Exhibit A
File No. 241464
1st Amendment to Detailed Planned Development
Holy Cathedral Church of God in Christ (aka Cathedral Heights)
7200 W. Florist Avenue
February 19, 2025

This 1st Amendment to the DPD will allow changes to the previously approved plans for the construction of a church as follows:

A NEW FACILITY FOR
HOLY CATHEDRAL CHURCH OF GOD IN CHRIST
MILWAUKEE, WISCONSIN

2 NORTHEAST ELEVATION
 A5 3/32" = 1'-0"

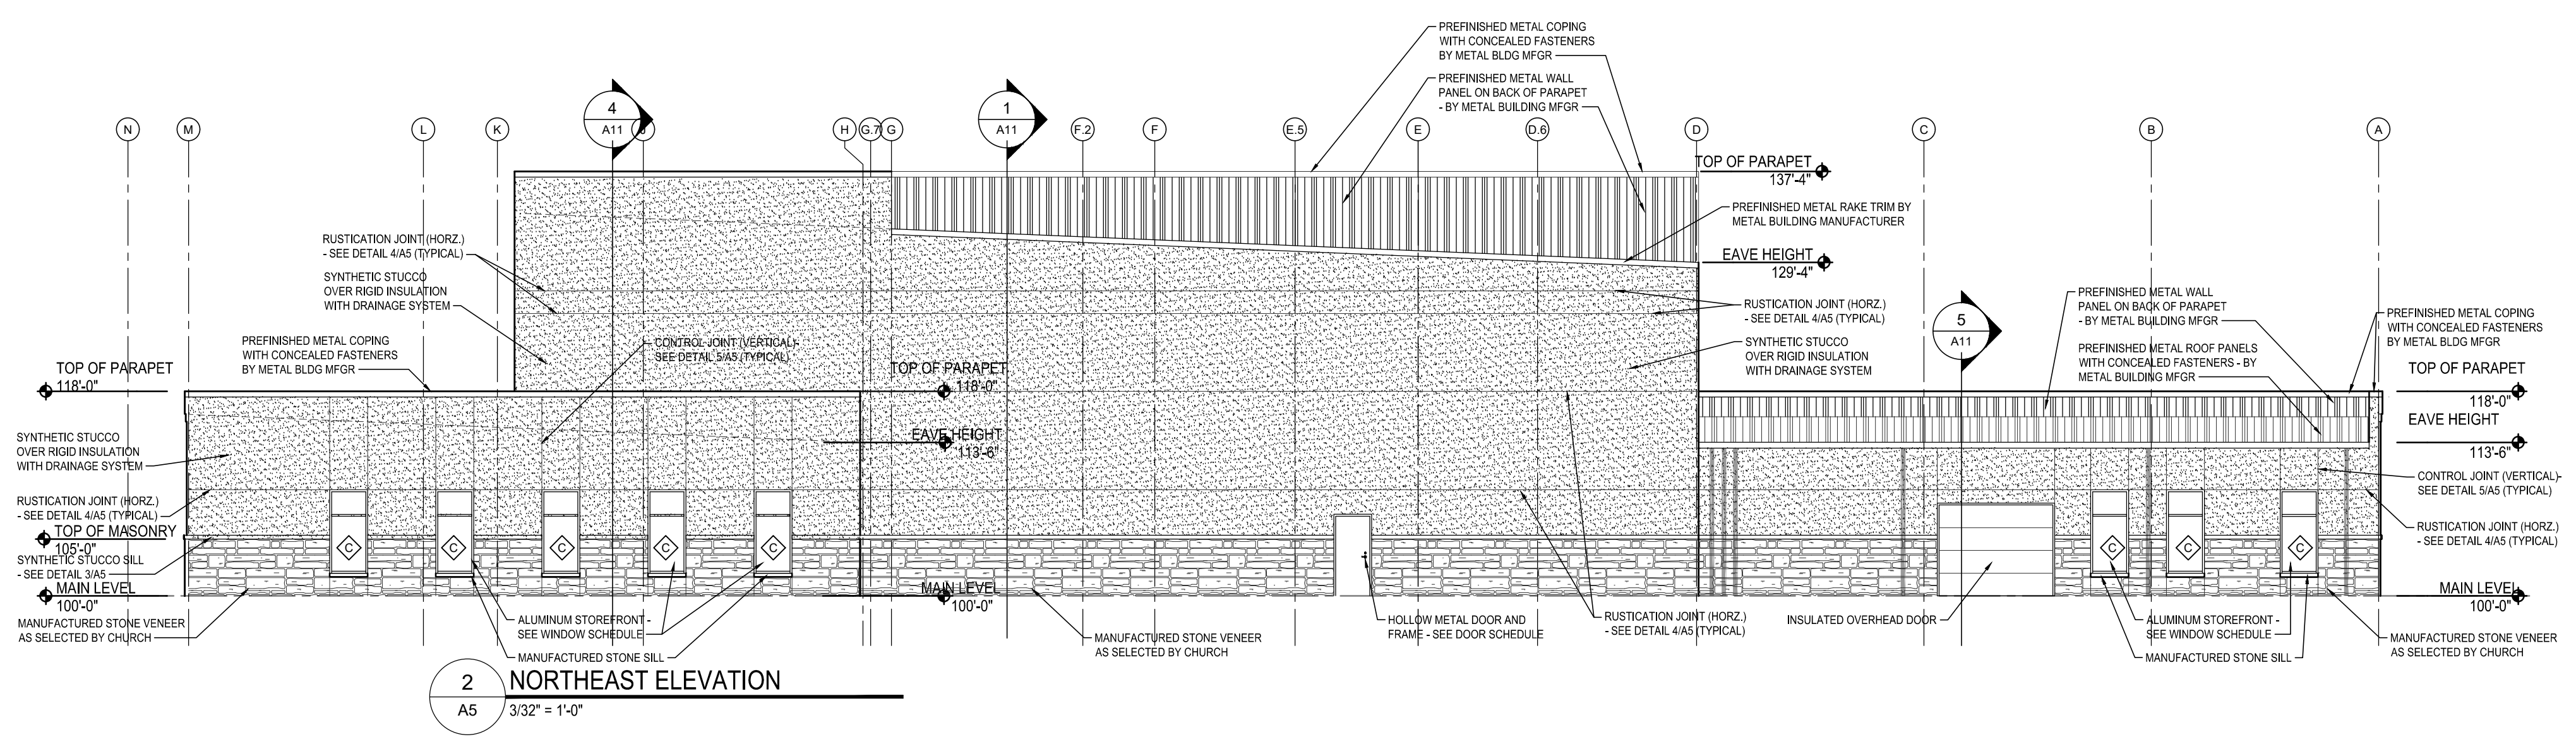
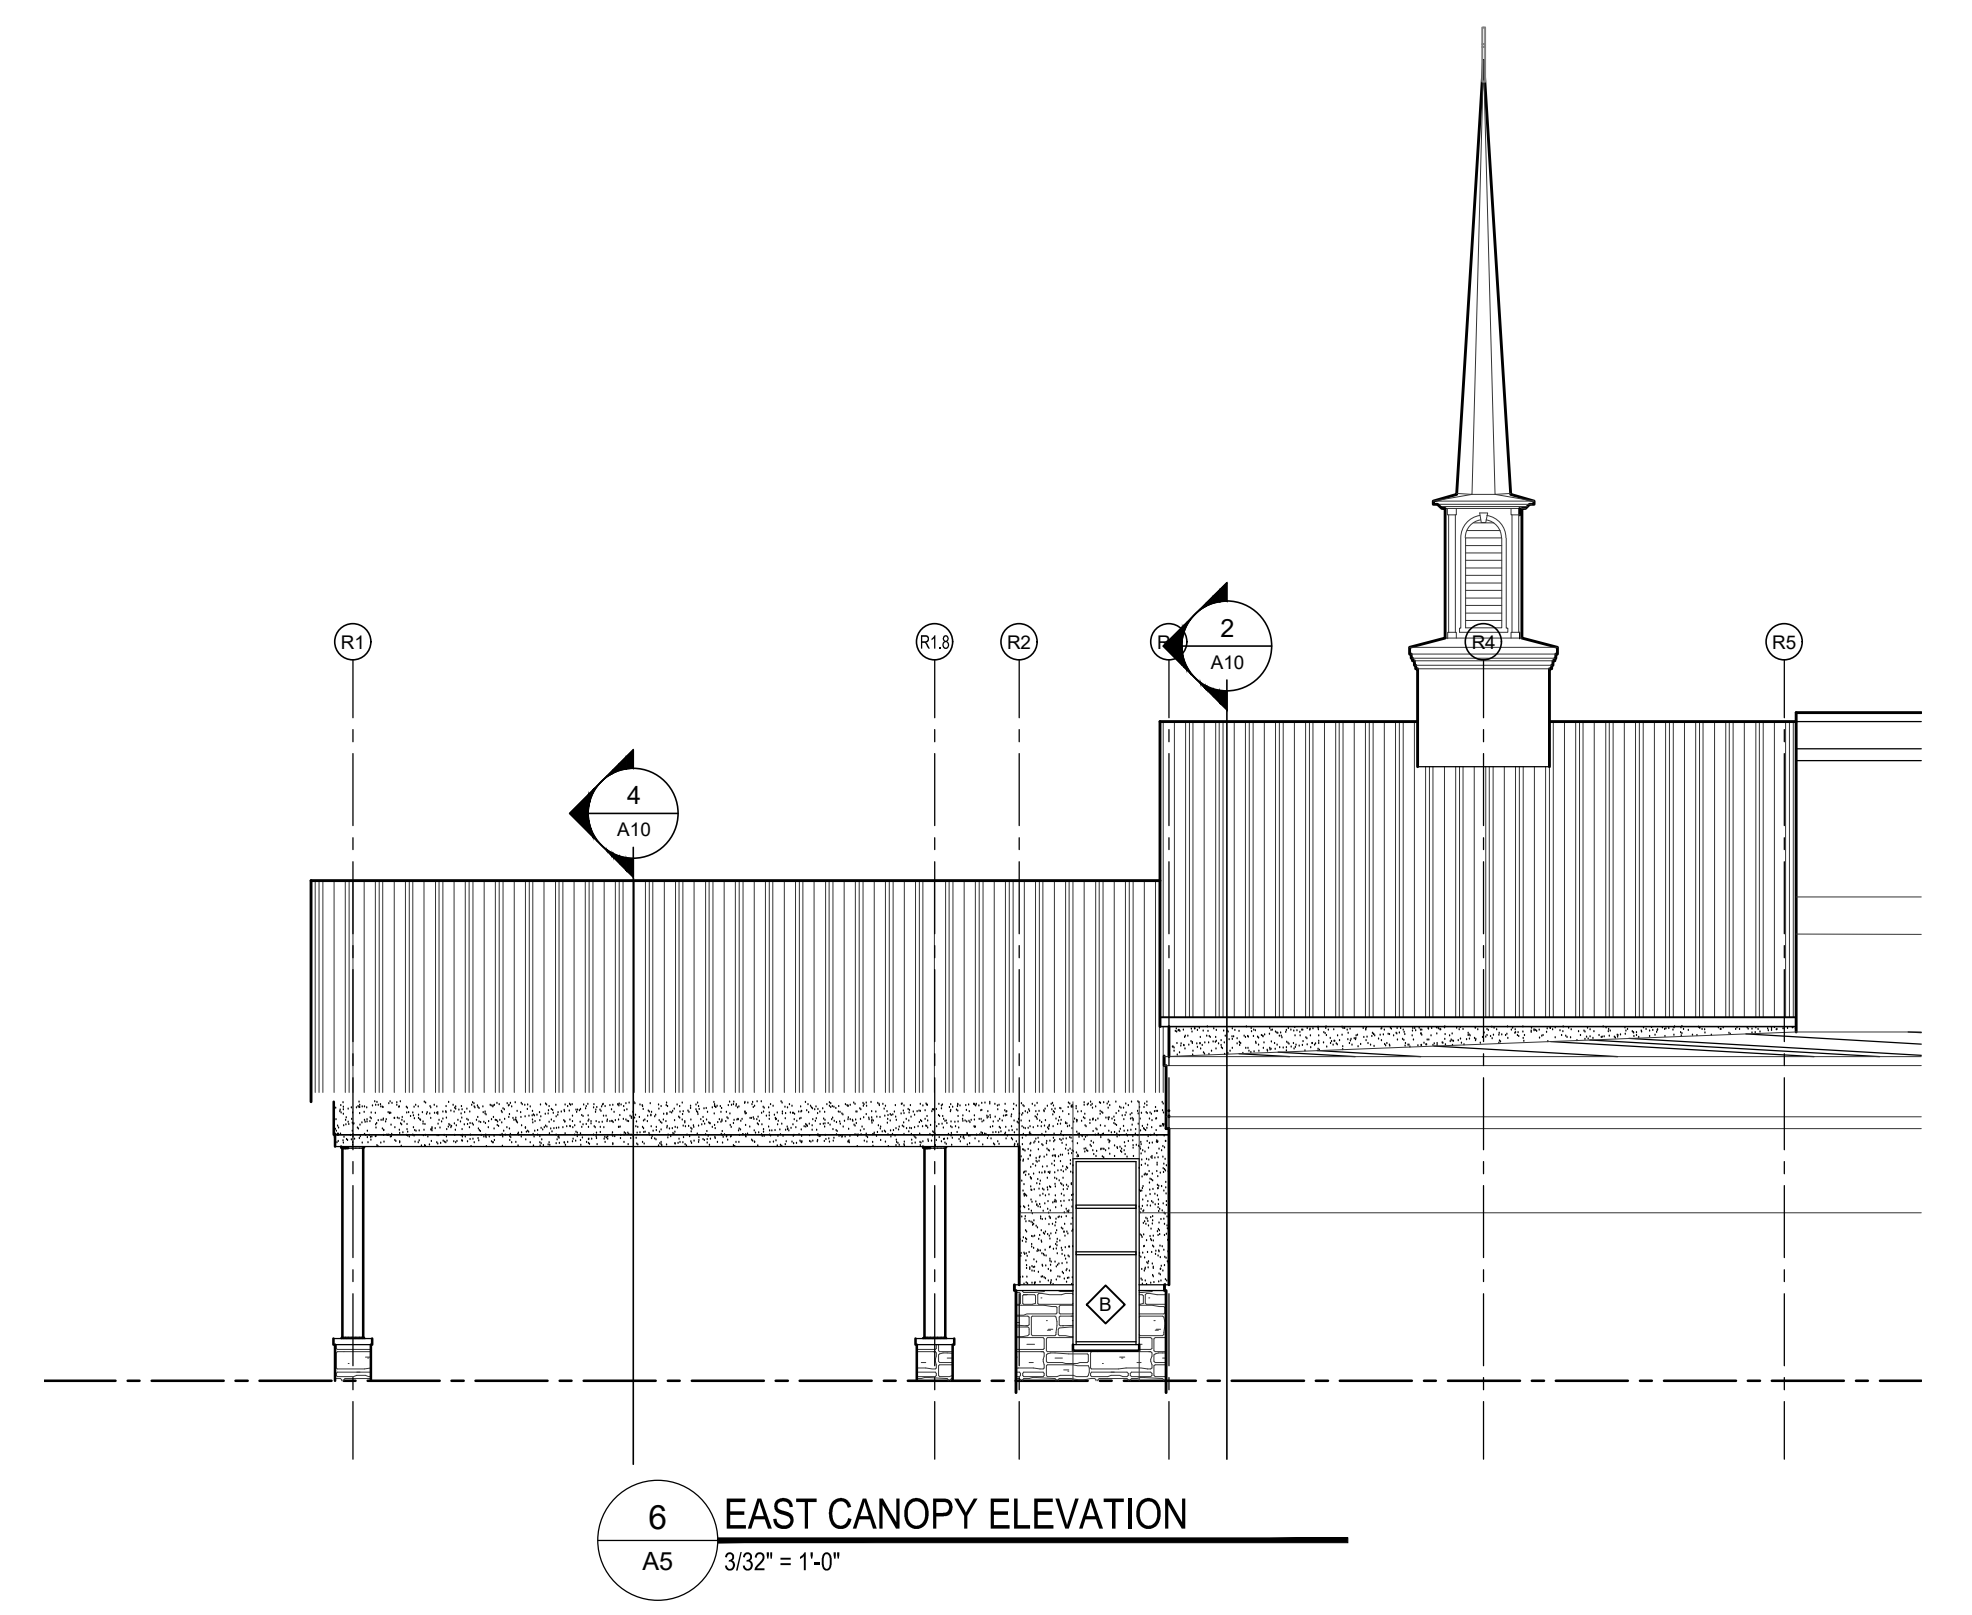
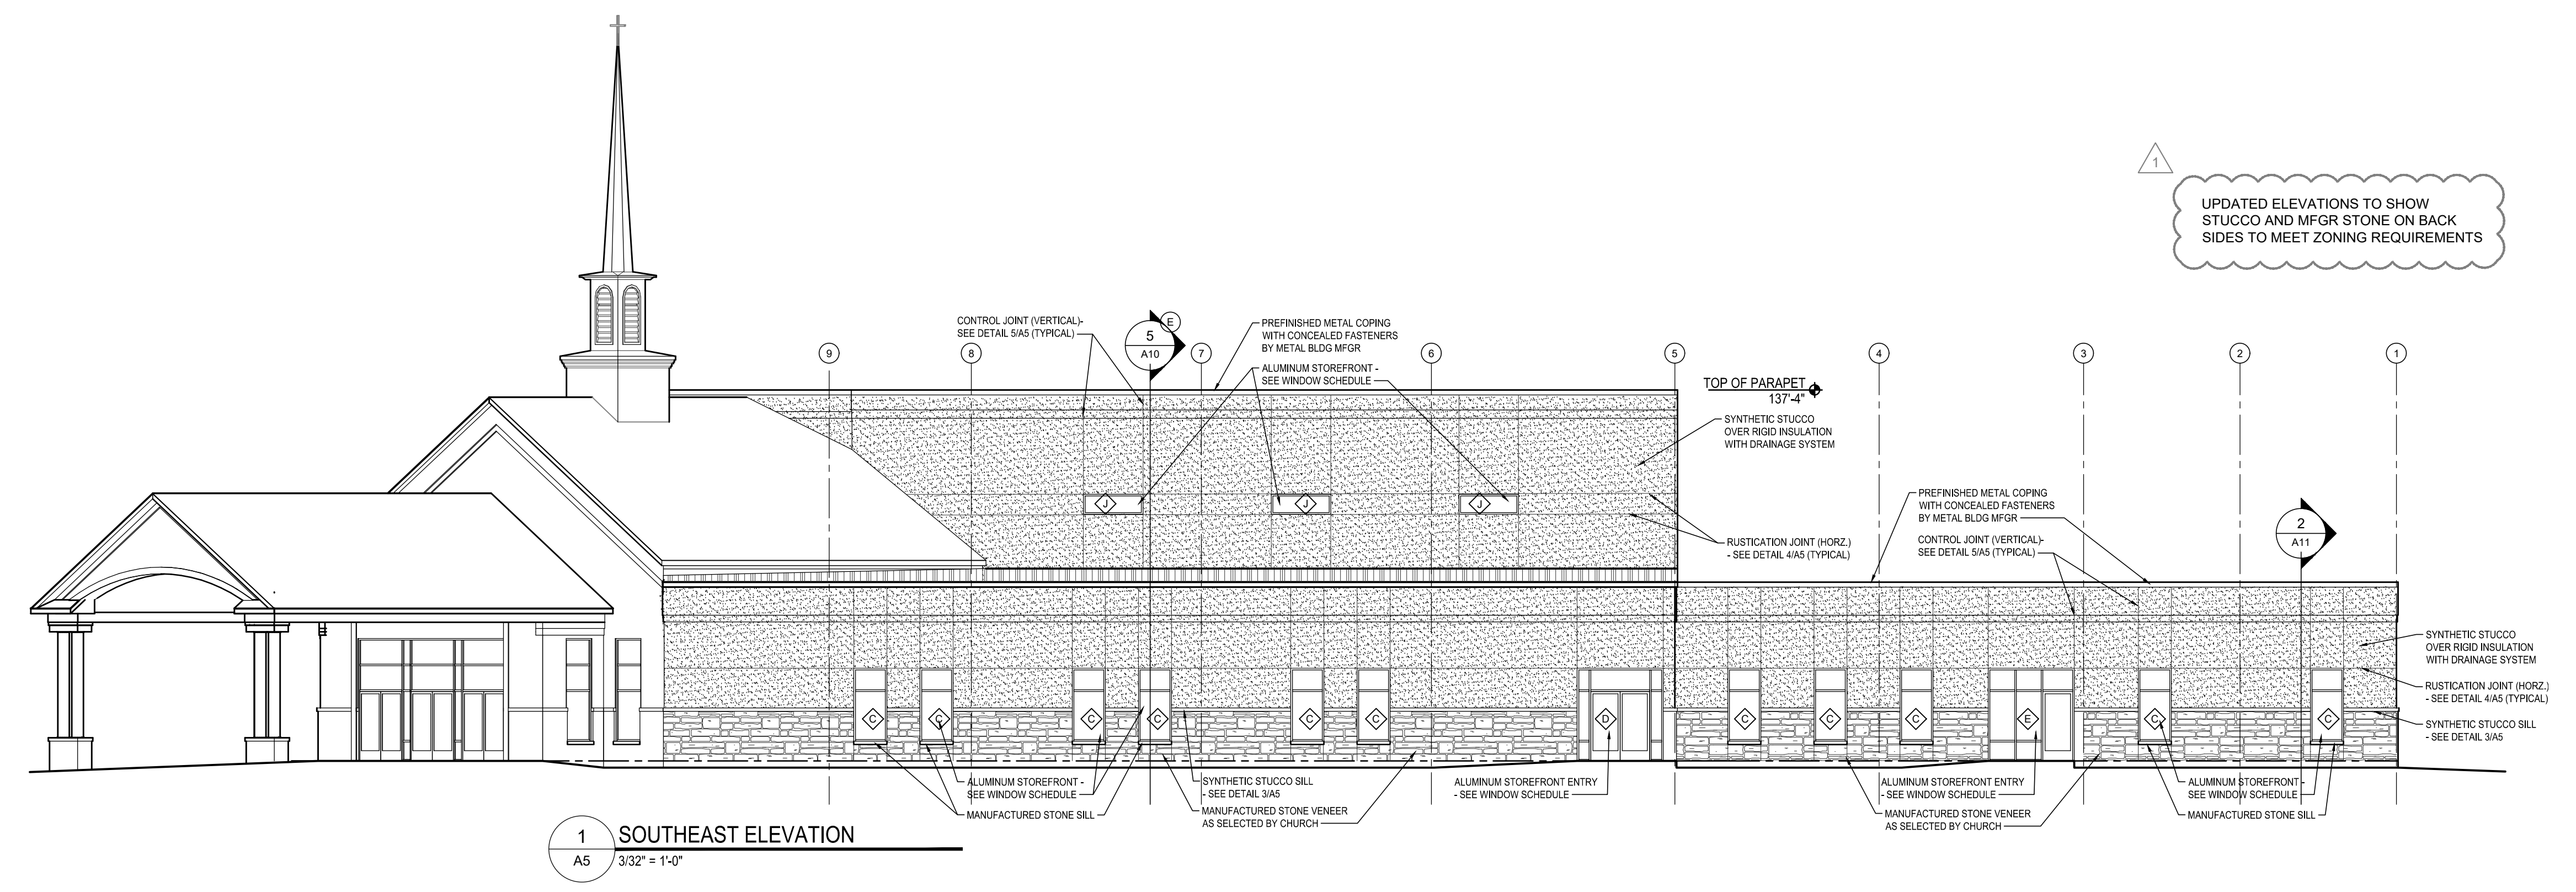
UPDATED ELEVATIONS TO SHOW STUCCO AND MFRG STONE ON BACK SIDES TO MEET ZONING REQUIREMENTS
